January 31, 1983

## TECHNICAL UPDATE

### POLE POSITION™

"REWINDING THE PULLEY CABLE"

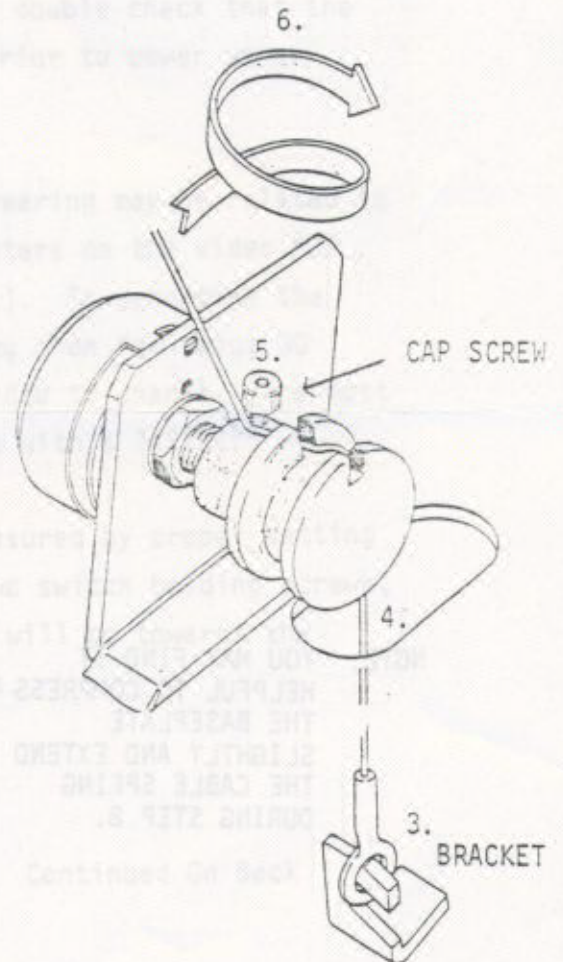
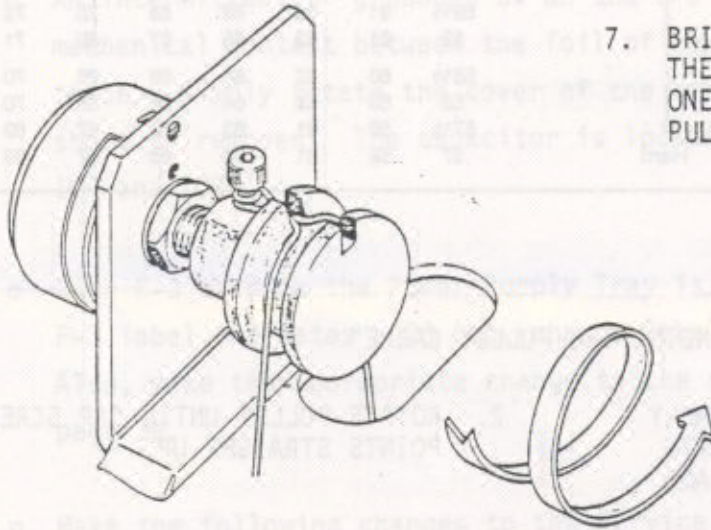
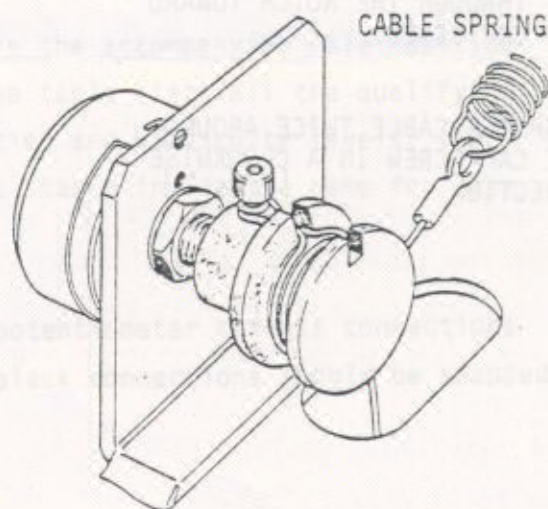
1. PLACE FOOT-PEDAL CONTROL ASSEMBLY UPSIDE DOWN ON WORK SURFACE WITH PEDAL IN FULLY-OPEN POSITION AND HINGED END AWAY FROM YOU.
2. ROTATE PULLEY UNTIL CAP SCREW POINTS STRAIGHT UP.
3. HOOK THE LARGER-DIAMETER EYELET OF THE CABLE TO THE FOOT-PEDAL BRACKET.
4. THREAD THE CABLE UP THROUGH THE BASE-PLATE OPENING.
5. WRAP THE CABLE 1/4 - TURN AROUND THE PULLEY AND BRING OUT THROUGH THE NOTCH TOWARD THE CAP SCREW.
6. WRAP THE CABLE TWICE AROUND THE CAP SCREW IN A CLOCKWISE DIRECTION.

- BRING THE CABLE BACK THROUGH THE NOTCH AND WRAP ONE AND ONE-HALF TURNS AROUND THE PULLEY.

- ATTACH THE SMALLER EYELET ON THE CABLE TO THE CABLE SPRING.

NOTE: YOU MAY FIND IT HELPFUL TO COMPRESS THE BASEPLATE SLIGHTLY AND EXTEND THE CABLE SPRING DURING STEP 8.
